# Access Compliance Report

## Public Rights-of-Way

### (Curb Ramps)

Intersection ID: 10017494		Main Street: MILHAVEN_LN		Cross Street: N/A		Location: NW													
ADA ID: F599110D32BE		Ramp Type: Directional1		Initial Pass/Fail: Fail		Overall Compliance: No		Severity Score: 13.75											
Codes/Mitigation Info/Possible Solution				Field Measurements/Component Compliance															
<div></div> <div>Street 1 NameENTRANCE</div> <div>Stop Condition-Street 1None</div> <div>Street 2 NameN/A</div> <div>Stop Condition-Street 2N/A</div>				Possible Solutions:		Compliance		Description		Data		Compliance		Description		Data			
				Remove & Replace Entire Ramp.		N/A		Ramp Length (in)		103.5		N/A		Grade Break?		N/A		N/A	
						Yes		Ramp Width (in)		65.0		N/A		Grade Break Slope (%)		0.0		0.0	
						No		Ramp Slope (%)		10.6		N/A		Grade Break XSlope (%)		0.0		0.0	
						Yes		Ramp XSlope (%)		2.5									
						N/A		Flare Type LT		N/A		N/A		Flare Type RT		N/A		N/A	
						N/A		Flare Slope LT (%)		N/A		N/A		Flare Slope RT (%)		0.0		0.0

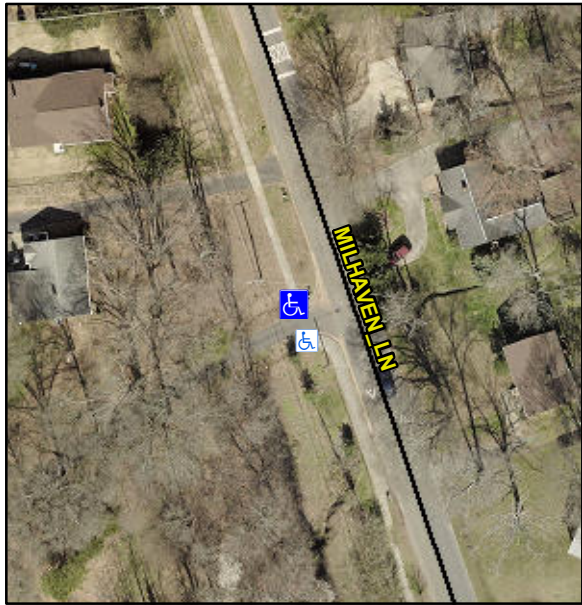
N/A		Flare Traversable LT?		N/A		N/A		Flare Traversable RT?		N/A		N/A	
						N/A		Landing Length (in)		0.0		N/A		DWS Provided?		N/A		N/A	
						N/A		Landing Width (in)		0.0		N/A		DWS Contrast?		N/A		N/A	
						N/A		Landing Slope (%)		0.0		N/A		DWS Length (in)		N/A		N/A	
						N/A		Landing X Slope (%)		0.0		N/A		DWS Full Width?		N/A		N/A	
						N/A		Landing Curb? (Y/N)		N/A		N/A		DWS Offset LT (in)		N/A		N/A	
						N/A		Shared Landing?		N/A		N/A		DWS Offset RT (in)		N/A		N/A	
						N/A		Gutter Ponding?		0.0		N/A		Gutter Slope (%)		N/A		N/A	
						N/A		Gutter Lip Ht (in)		0.0		N/A		Gutter X Slope (%)		N/A		N/A	
						N/A		Painted X Walk1?		No				Road Slope (%)		2.0		2.0	
								X Walk 1 Direction		To SE				Road X Slope (%)		5.9		5.9	
								X Walk 1 Width (in)		N/A				Clear Space?		N/A		N/A	
								X Walk 1 Slope (%)		2.0		N/A		Clear Space to XWalk (in)		N/A		N/A	
				X Walk 1 X Slope (%)		5.9		N/A		Storm Grate/Utility Hazard?		N/A		N/A

N/A		Ramp inside XWalk1?		N/A		Storm Grate/Utility Type									
				N/A		Any Obstructions?		N/A				N/A		N/A					
						Obstruction Type				Yes		Surface Condition? (G/P)		Good					
								N/A		N/A		Curb Slope (%)		17.9					
				Total Cost:		\$		1600.00
